December 22, 2023

Reg.: Response to Traffic Comments
Darwin Common, Darwin Lane, Walpole, MA

Chappell Engineering Associates, LLC (CEA) has prepared this letter to respond to traffic peer review comments by Tetra Tech in their letter to the Town of Walpole dated October 8, 2023. The Tetra Tech letter included comments specific to the Traffic Assessment¹ prepared by Ron Müller & Associates for the above-referenced project. Tetra Tech's comments are reiterated below followed by CEA's responses. The comments are numbered to correspond with the review letter.

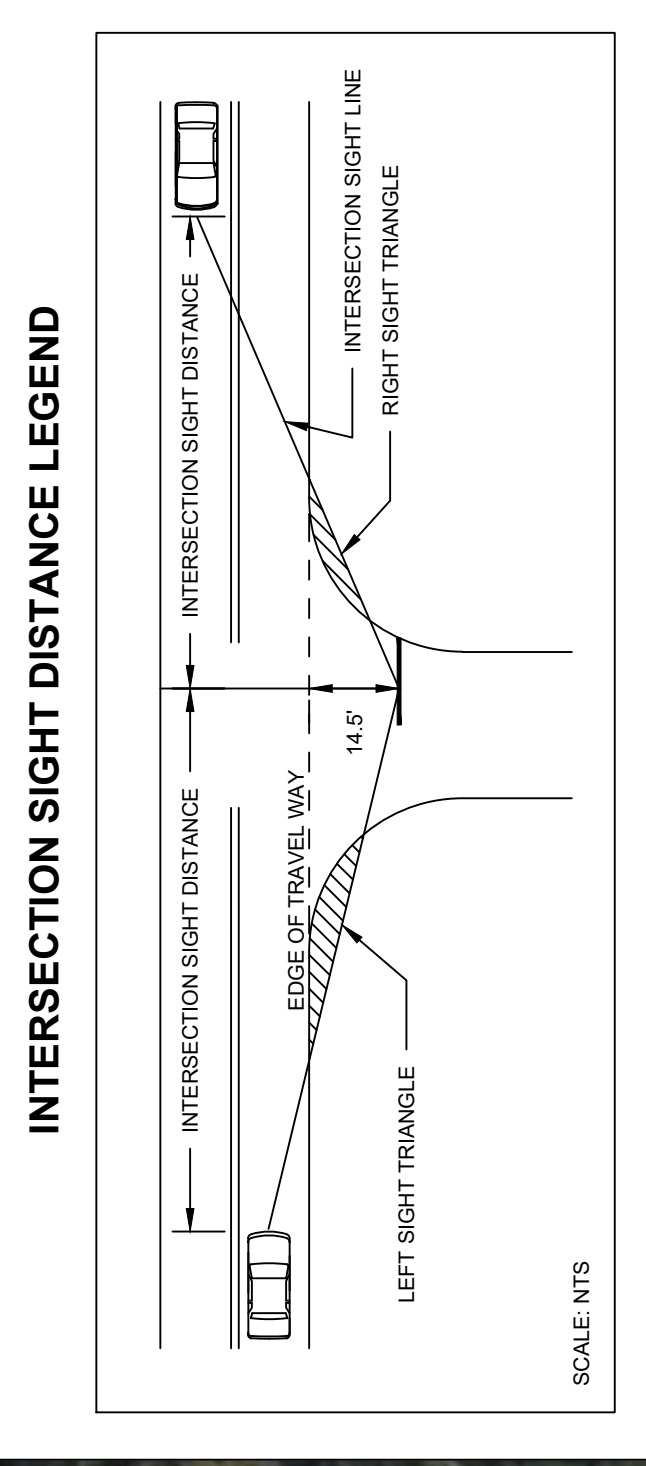
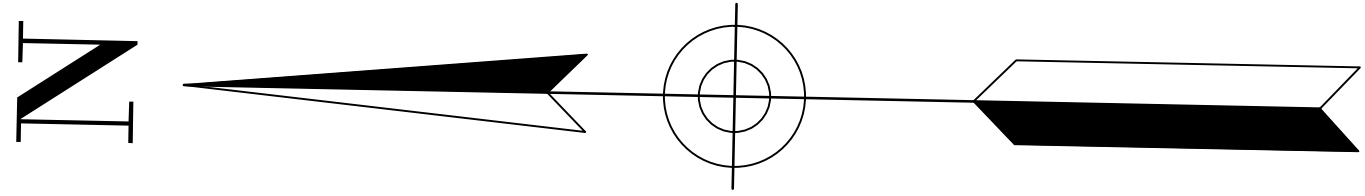
Comment 62: *“The traffic memo recommends that any proposed landscaping, fences, walls, or signs in the vicinity of the site driveway be kept low to the ground (less than 2 feet above street level) or set back outside the sight triangles as defined by AASHTO. Tetra Tech recommends that the Applicant include sight distance triangles on the final site plans showing the areas to remain clear of obstructions (i.e., signage, vegetation, etc.) to ensure that safe stopping sight distance and intersection sight distance will be met.”*

Comment 63: *“Common Street has curved horizontal and vertical alignments through the intersection with Darwin Lane. Tetra Tech recommends that the Applicant prepare sight distance plans and profiles of this intersection to demonstrate that adequate sight distance is provided including stopping sight distance for the entire travel lane width in each direction on Common Street.”*

Response 62: The intersection sight distance (ISD) sight triangles at the intersection of Darwin Lane and Common Street are shown attached. It should be noted that no improvements or signage are proposed at this intersection. Under existing conditions more than adequate sight distance exists and both the minimum required and desirable sight distances are exceeded.

Response 63: Per Comment 62, ISD sight triangles have been shown on the attached plans. Survey, including elevation data, at the intersection of Common Street and Darwin Lane was not collected as part of the project since no improvements or signage are proposed at this intersection. A field review of sight distance confirms that 500+ feet of sight distance exists along Common Street looking both east and west of Darwin Lane, see Figures 1 and 2 below.
